Additional Information Requested, 1Q2022 GW Report, Lyons Quarry, M1977-208

RE: Additional Information Request
Lyons Quarry, Permit No. M-1977-208
Y22Q1 Groundwater Monitoring Report, C-Pit

Figure A Time trend plots for CEM-001

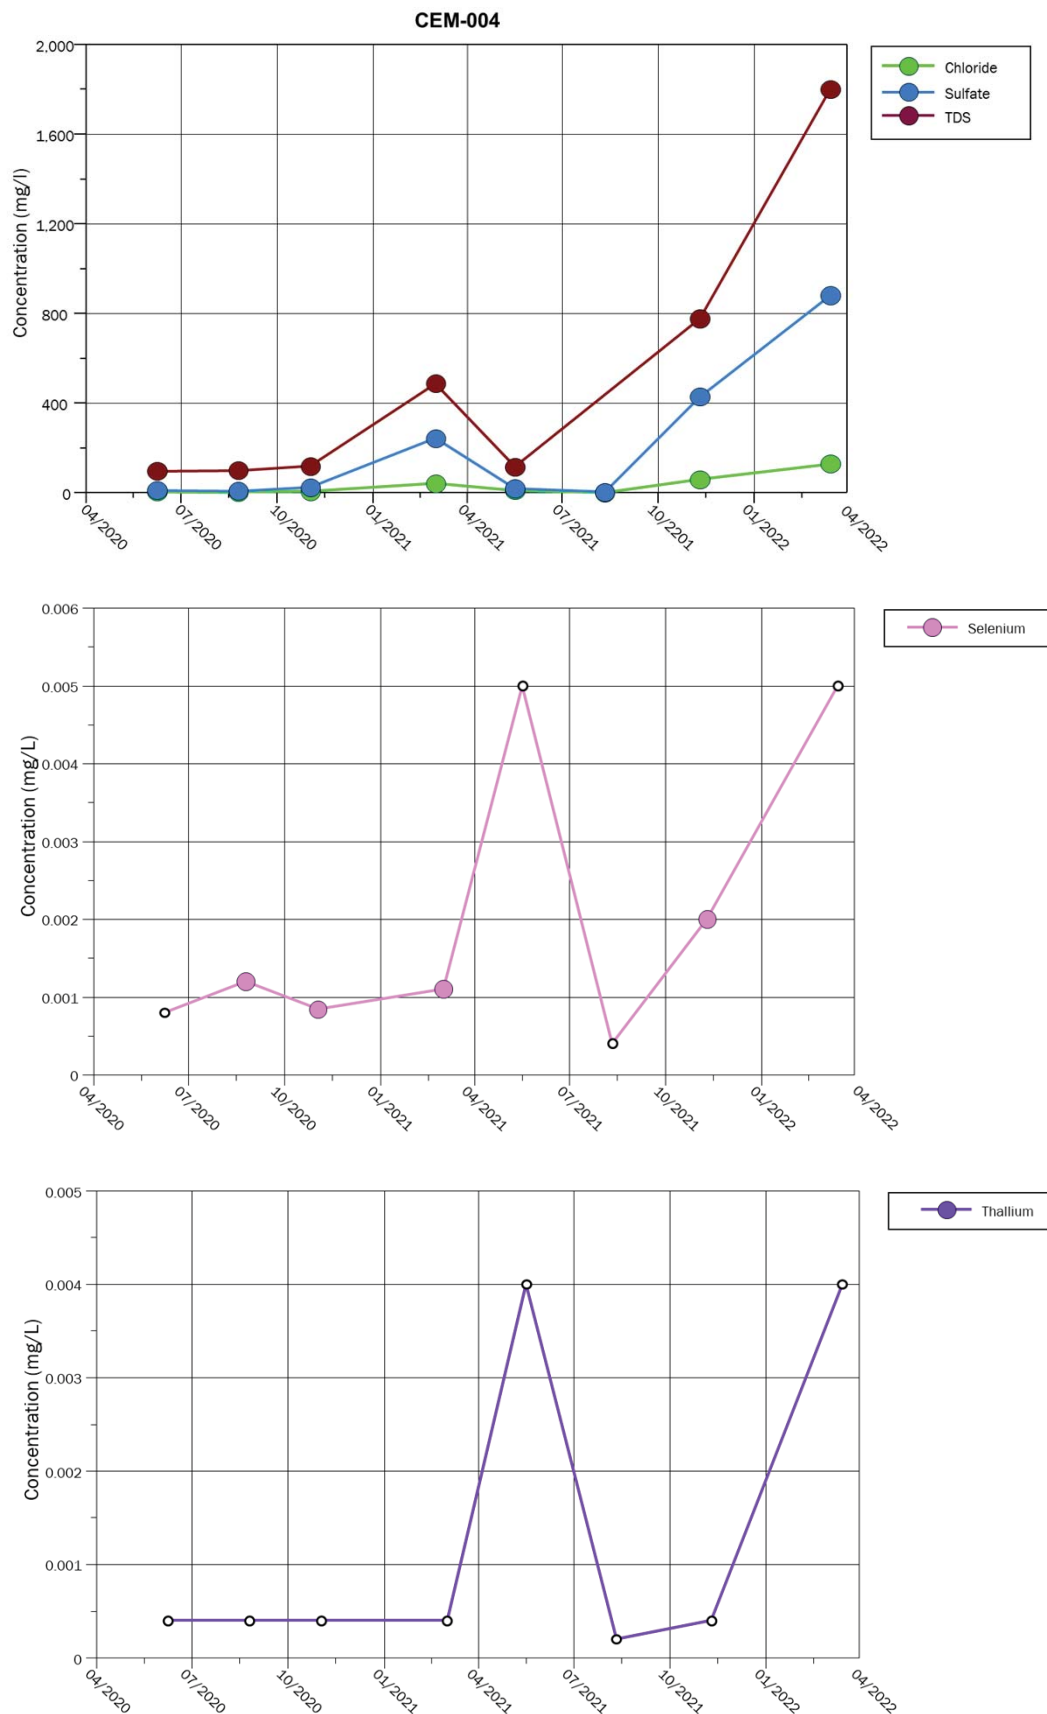
4. Please provide graphs for analyte concentrations for each location that depict trends over the last eight (8) quarters.

Graphs depicting analyte concentrations over the past eight (8) quarters for each CEM-001, CEM-004, and C-pit are enclosed as Figures A, B, and C, respectively.
